PHILADELPHIA ELECTRIC COMPANY

January 28, 1985

SUBJECT: Limerick Generating Station, Units 1 and 2, Organizational Changes  
in the PECO Electric Production Department

Attached are draft changes to FSAR Section 17.2, Figures 17.2-2, 3, 4, 5, & 15 and related 260 Series questions which describe the subject changes. These changes have been reviewed and it has been determined that the changes do not reduce the commitments in the QA Program previously approved by the NRC.

FIGURE 17.2-2 REV. 21, 06/83

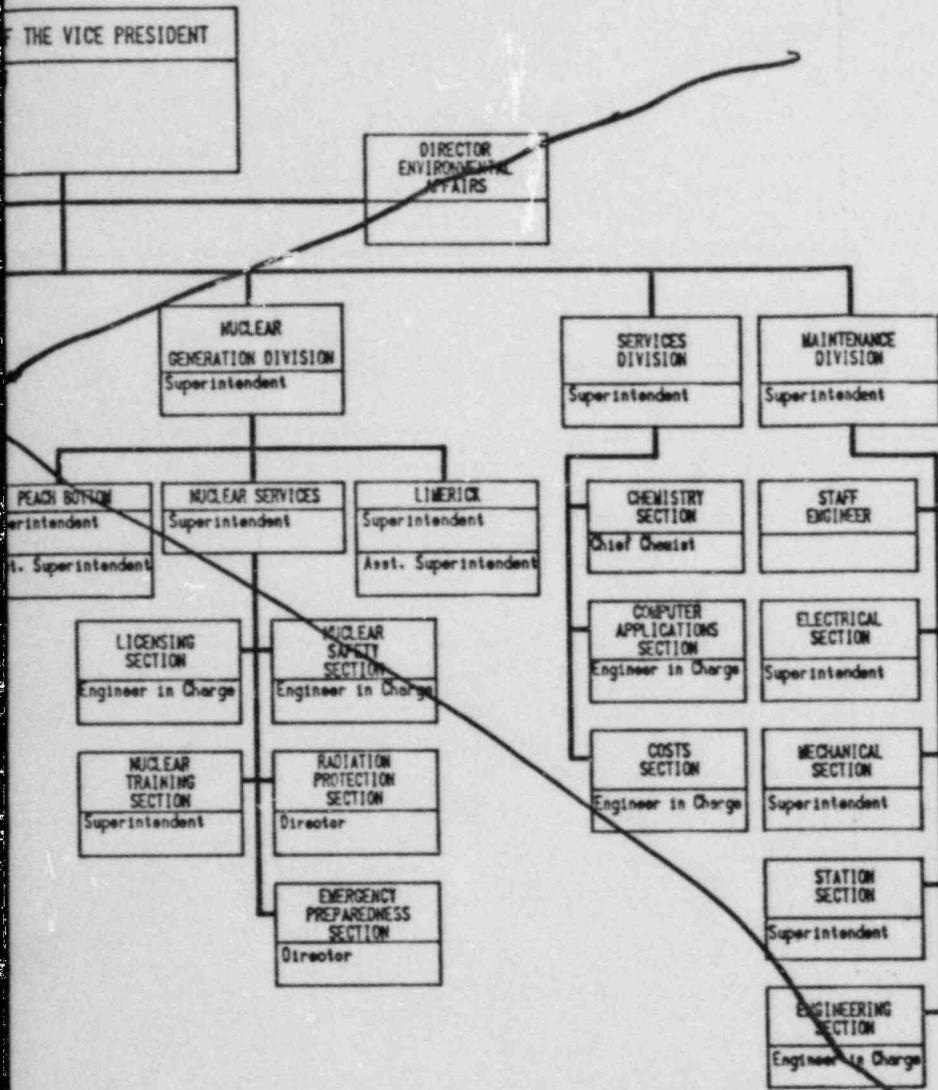
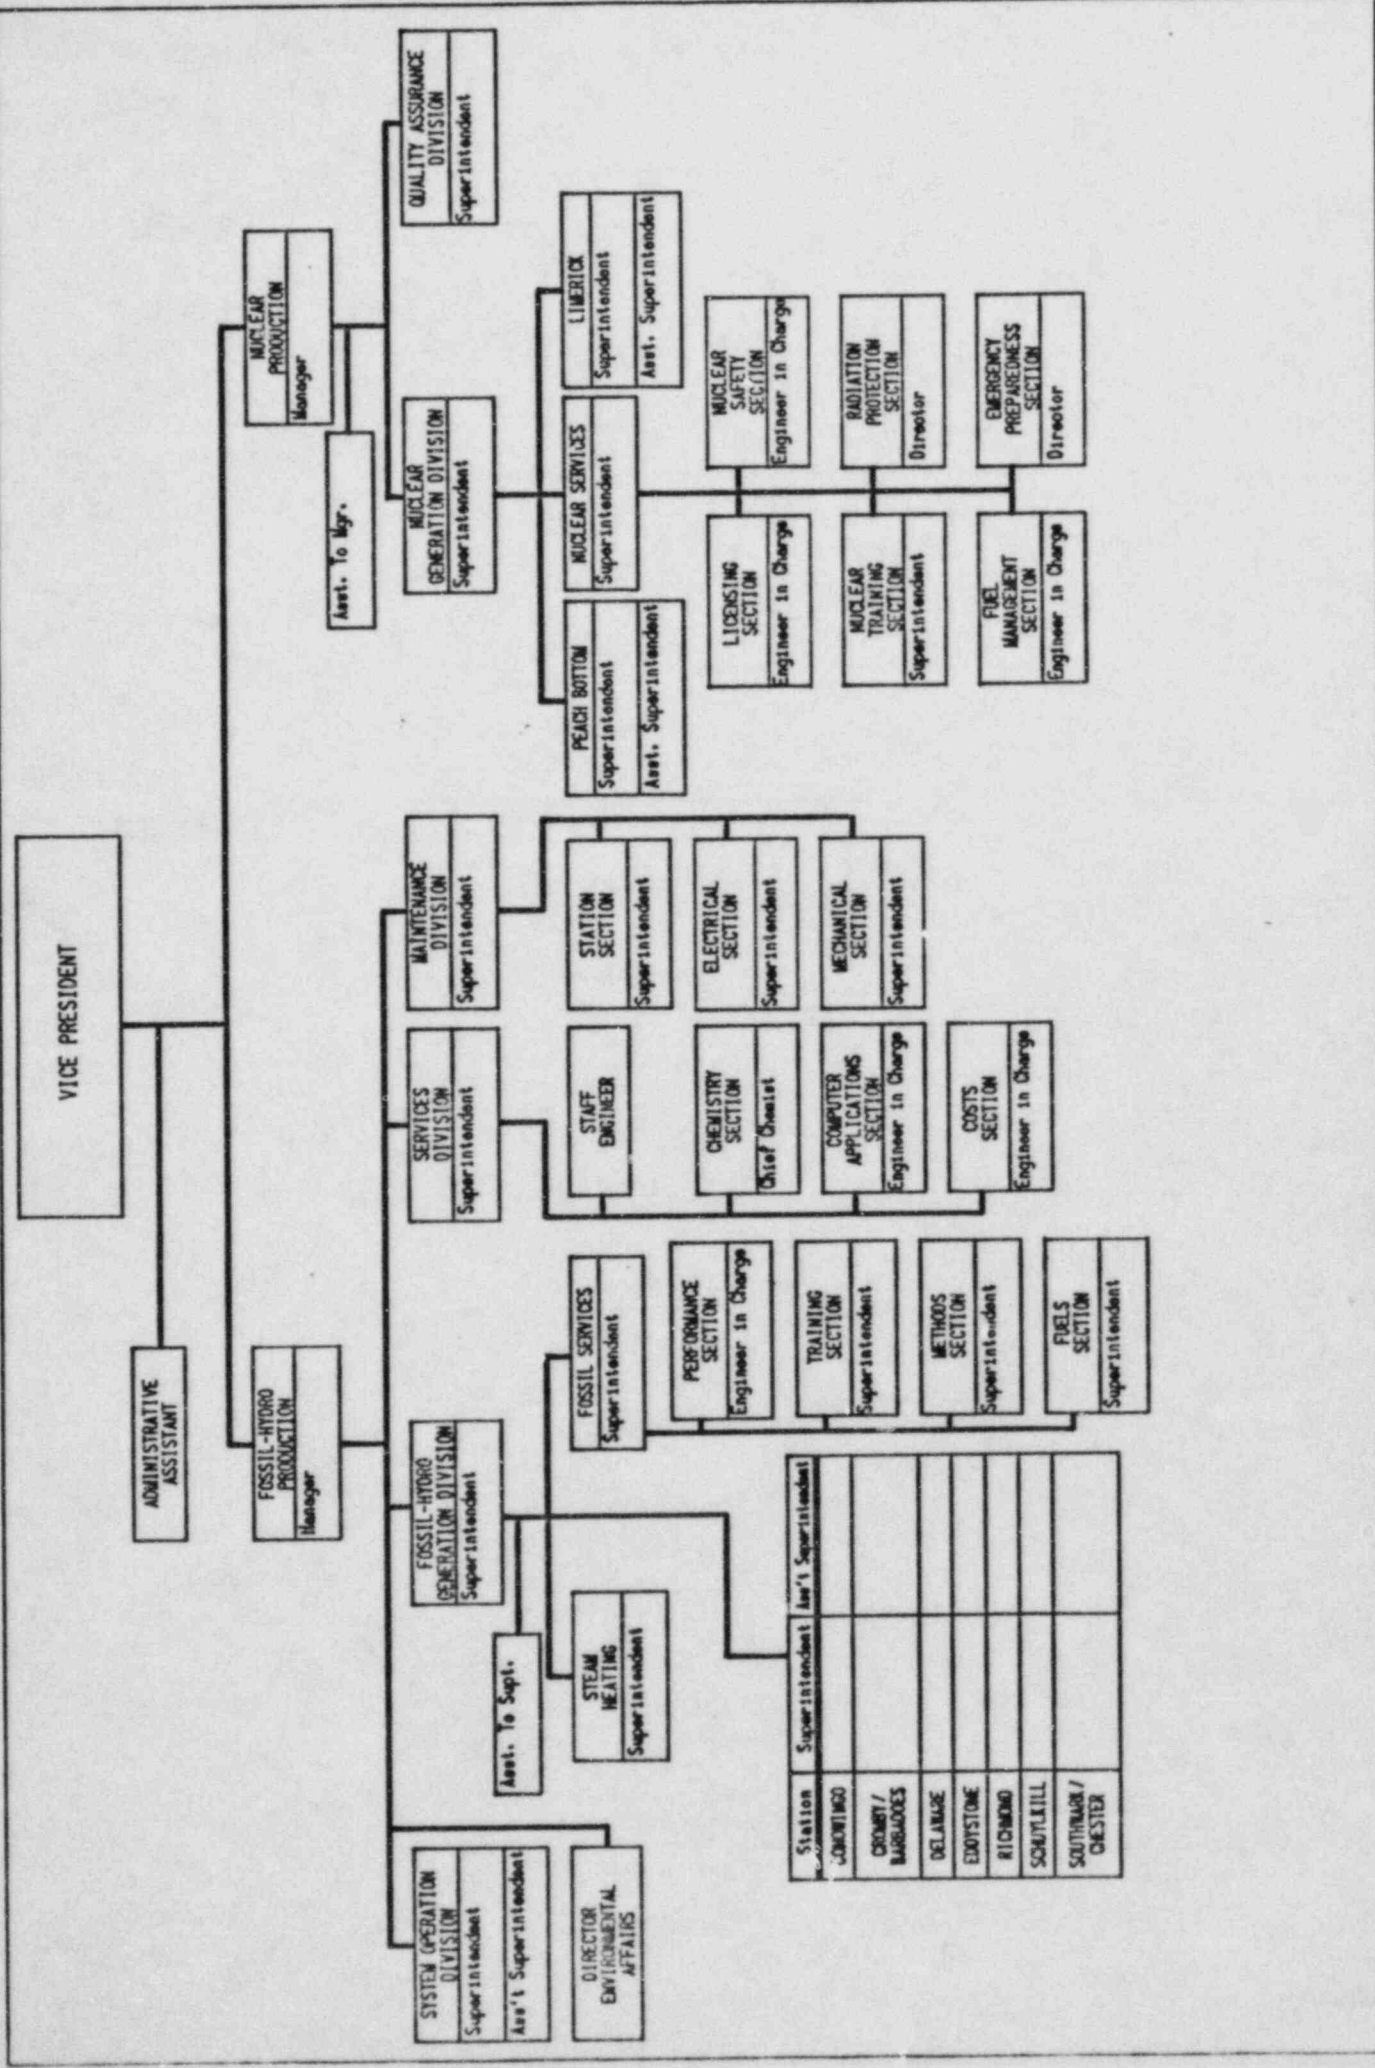
The organization of the Electric Production (EP) Department is shown in Figure 17.2-2.

*Manager - Fossil/Hydro*  
The Department is under the direction of the Vice President - Electric Production, assisted by the Manager - ~~Electric Nuclear~~ *Production and the* Production. They are responsible for the operation, maintenance and modification of the Company's electric generation facilities and establishment and implementation of Electric Production Department Quality Assurance Program, goals, and objectives.

FIGURE 17.2-3 REV. 17, 02/83

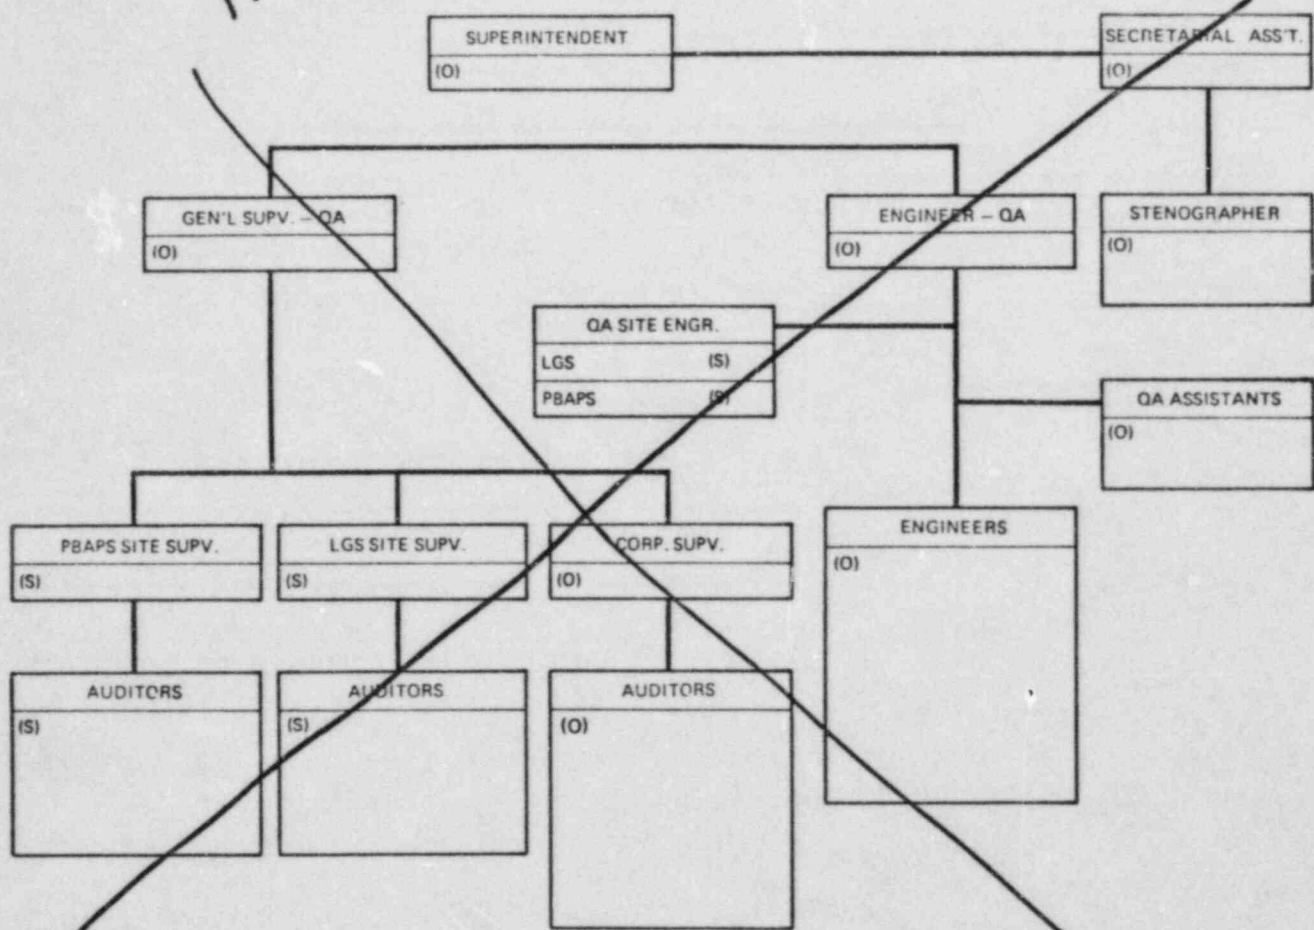
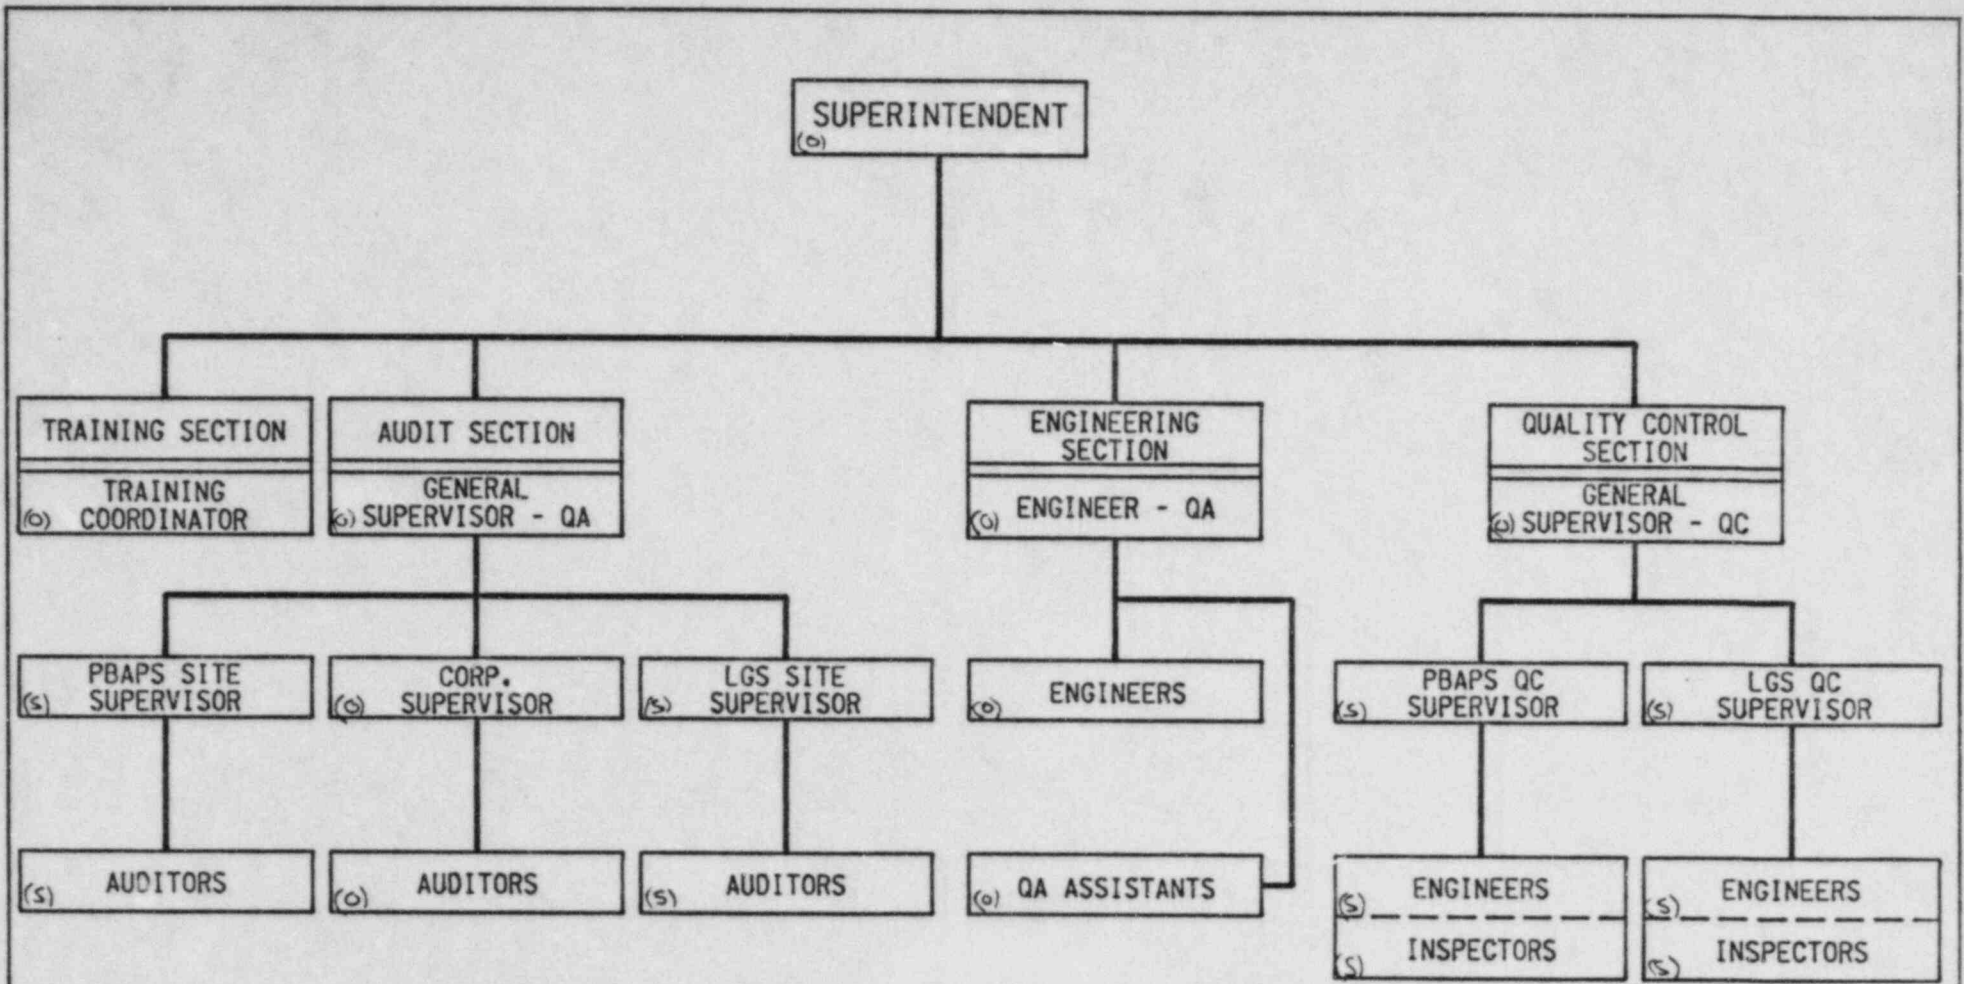
The Quality Assurance Division (Figure 17.2-3) is responsible for the overall Quality Assurance Program of the Electric Production Department within the framework of corporate Quality Assurance Policy as set forth in the Introduction.
